METROPOLITAN GOVERNMENT OF NASHVILLE AND DAVIDSON COUNTY

STAFF RECOMMENDATION
1711 Linden Avenue
October 16, 2013

Application: New construction- addition
District: Belmont-Hillsboro Neighborhood Conservation Zoning Overlay
Council District: 18
Map and Parcel Number: 10416019800
Applicant: Brian Haun, Architect
Project Lead: Sean Alexander, sean.alexander@nashville.gov

Drawings:
 First and Second Floor Plan
 Date:
 09.30.13

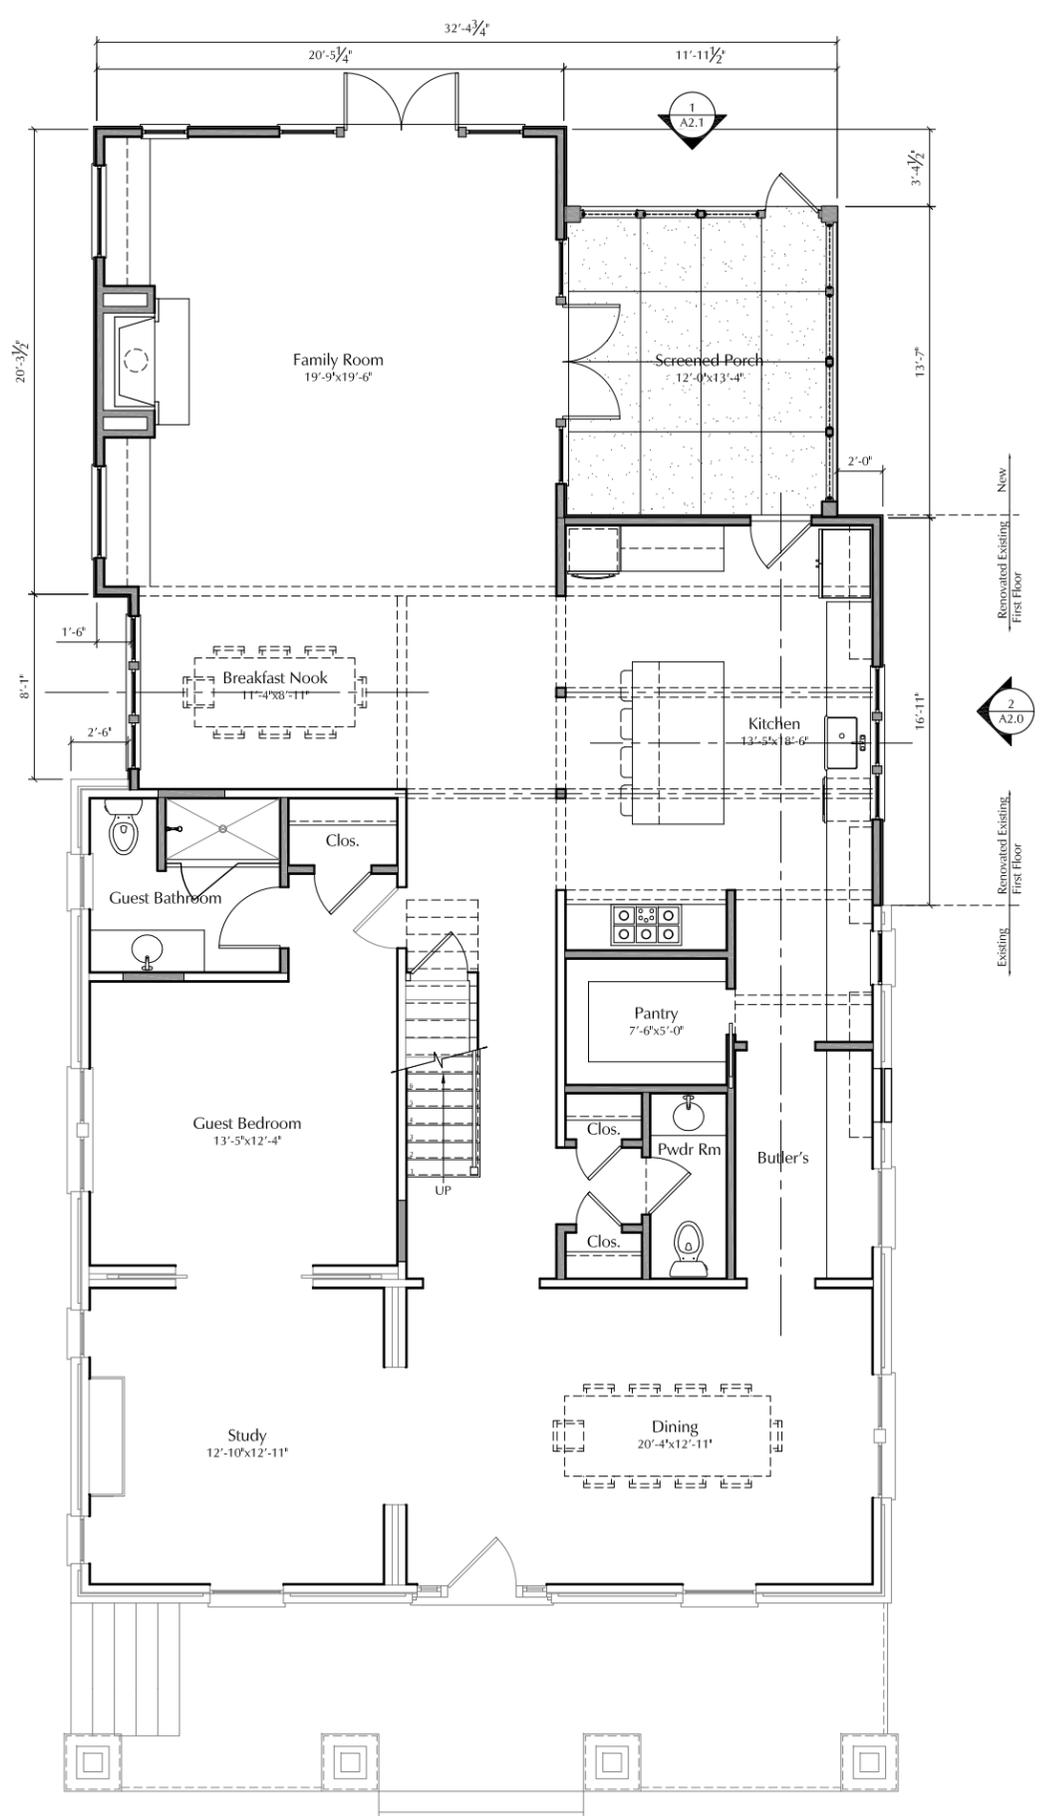
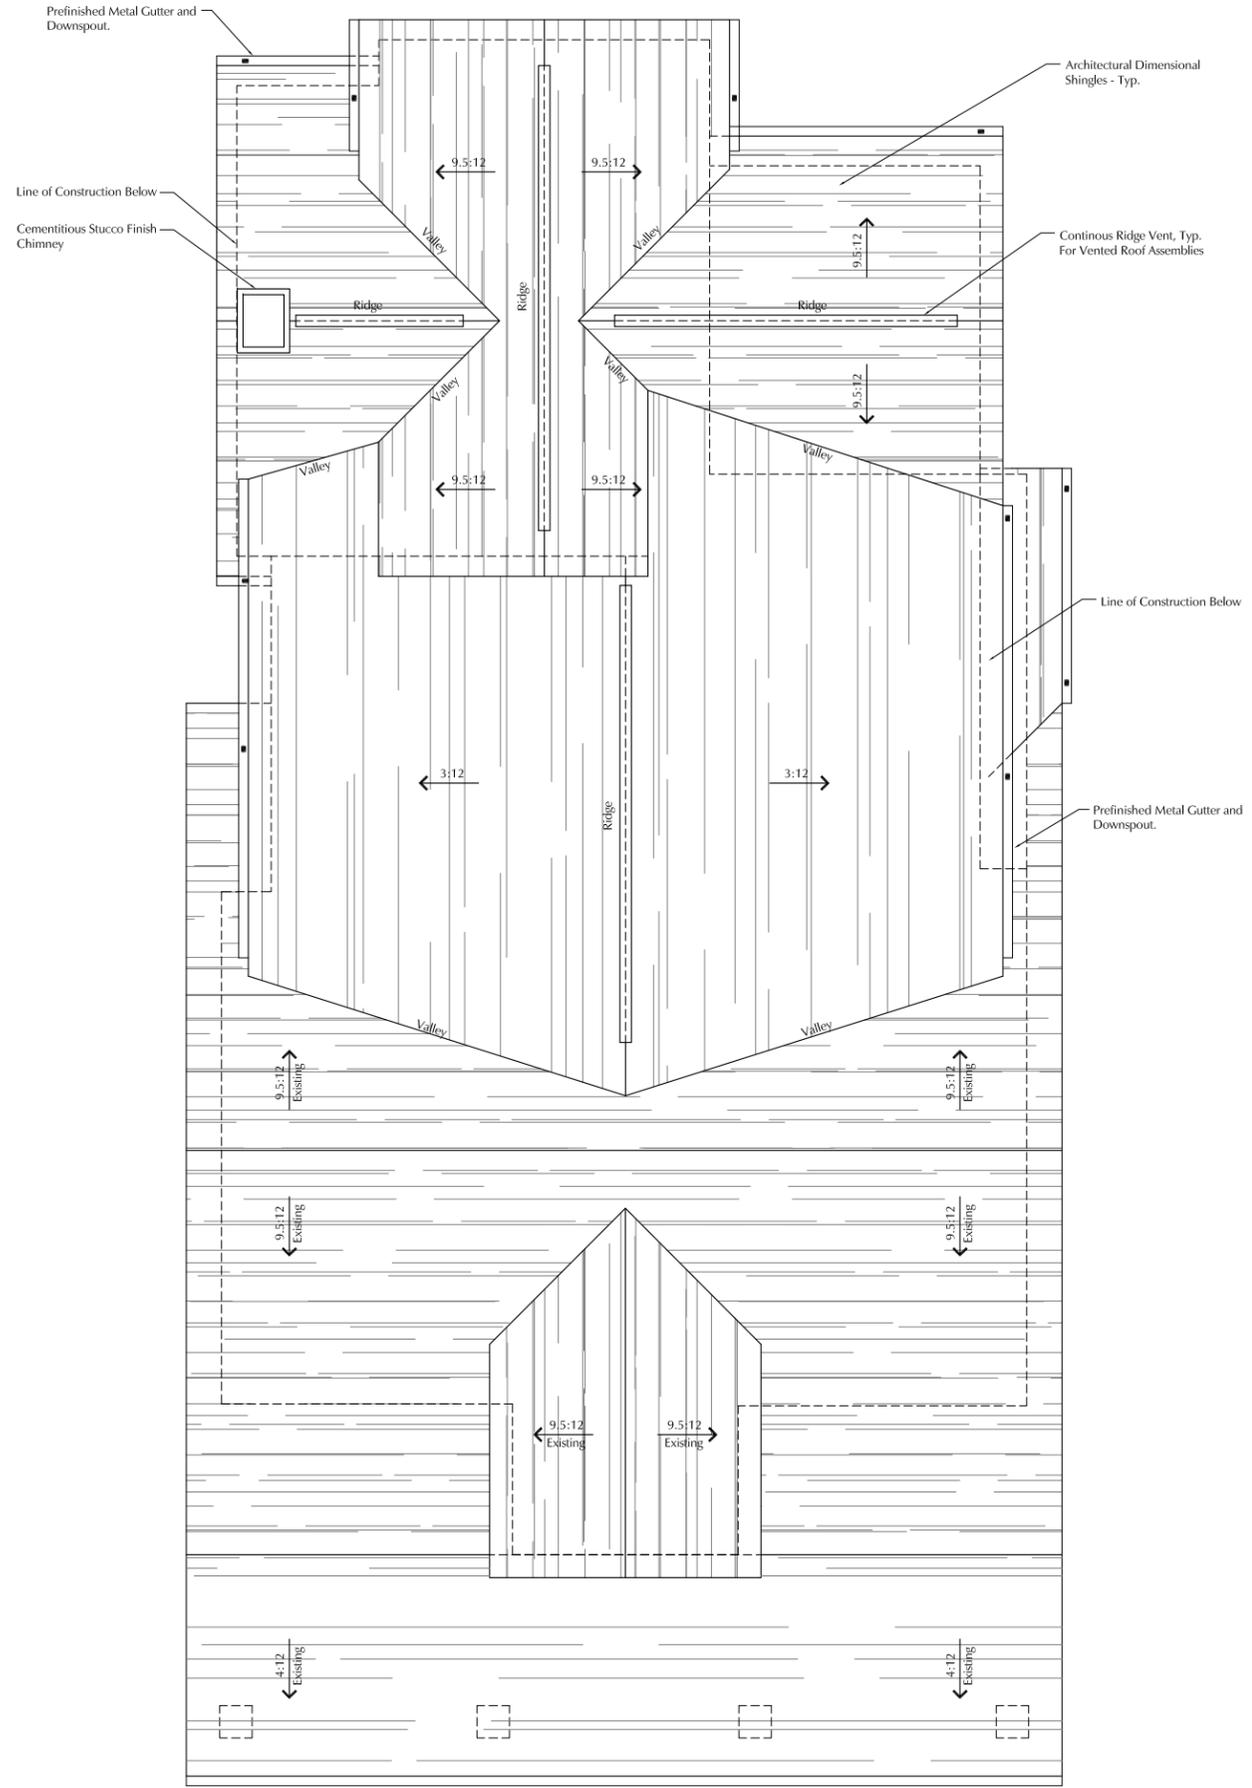
Proportion and Rhythm of Openings: No changes to the window and door openings on the existing house were indicated on the plans on the front or left side. The two rear-most windows on the right side of the historic house will be modified, but the rhythm of openings will remain apparent. The windows on the proposed addition are all generally twice as tall as they are wide, thereby meeting the historic proportions of openings. There are no large expanses of wall space without a window or door opening. Staff finds the project's proportion and rhythm of openings to meet Section II.B.1.g.

Roof Plan

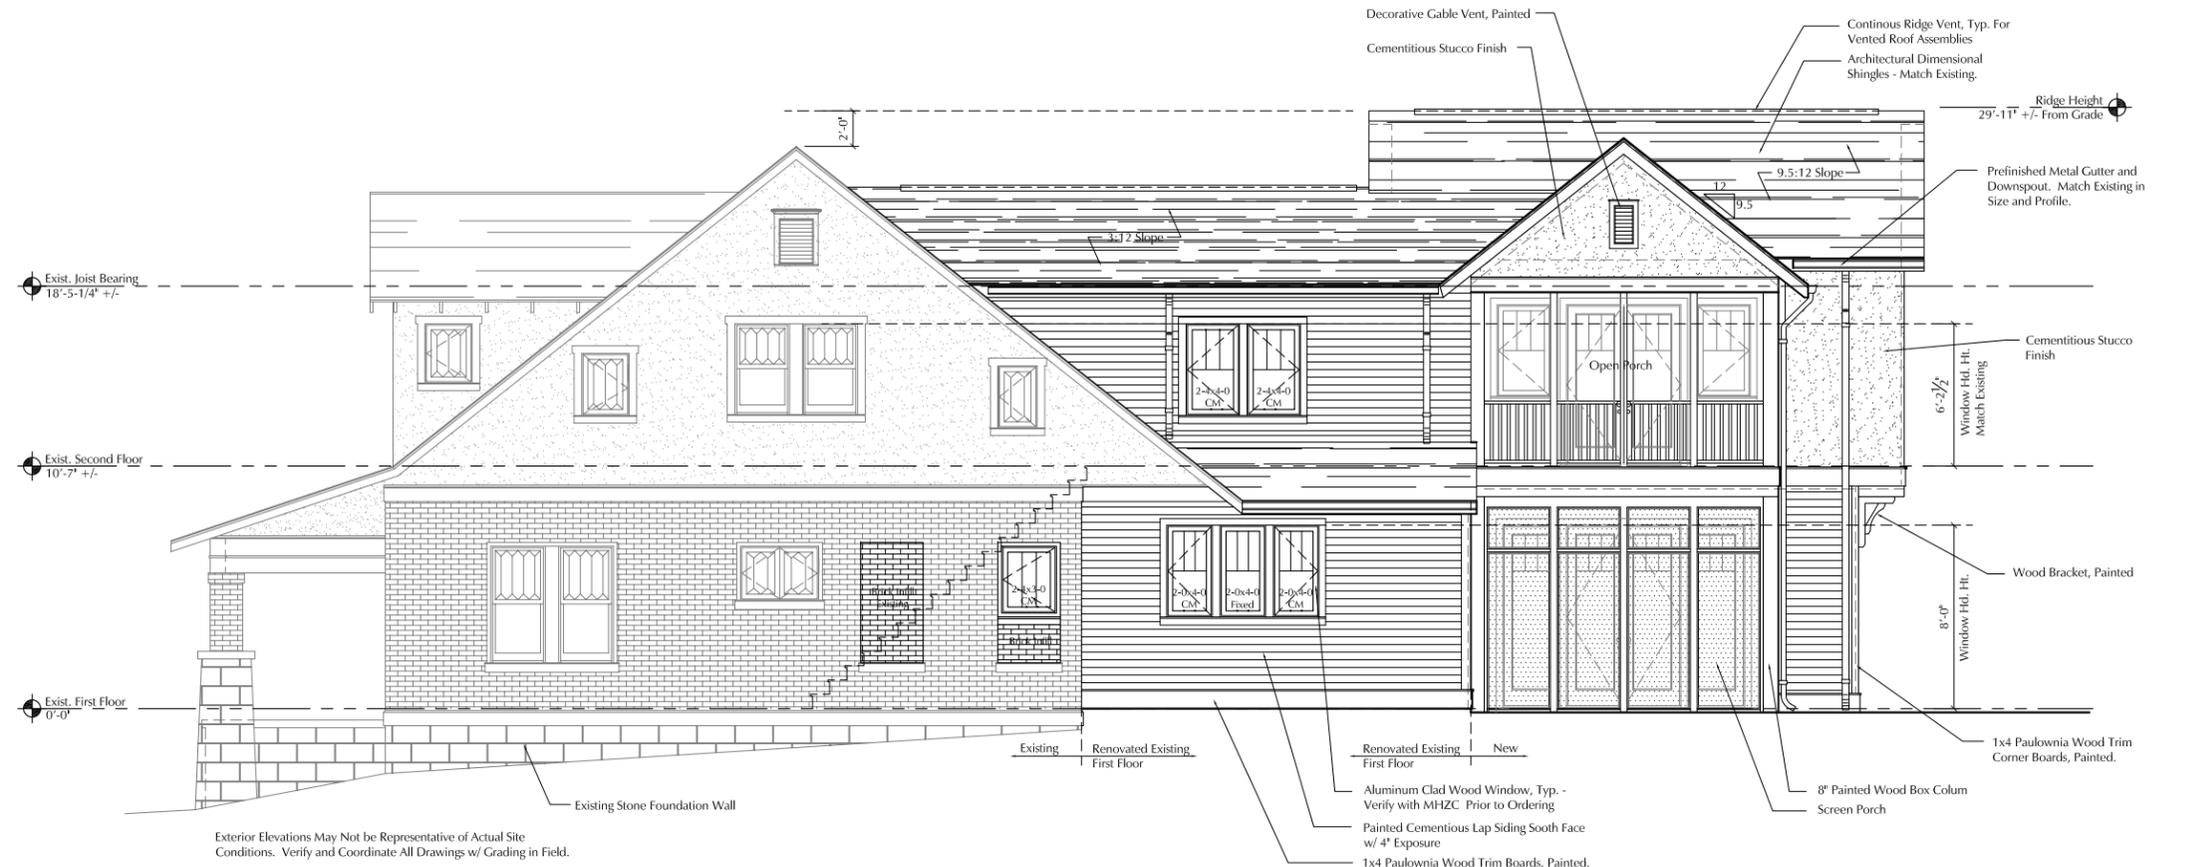
The roof of the addition will have two components. The main component will be a complex/cross gable with a pitch of 9.5:12, matching the shape and pitch of the house's primary roof. Tying this roof into the rear slope of the existing gable will be a 3:12 pitched "saddle." There will be a stuccoed chimney on the ridge of side-gabled roof of the addition. These roof forms are common to similar house forms throughout the overlay and are compatible with the roof of the historic house.
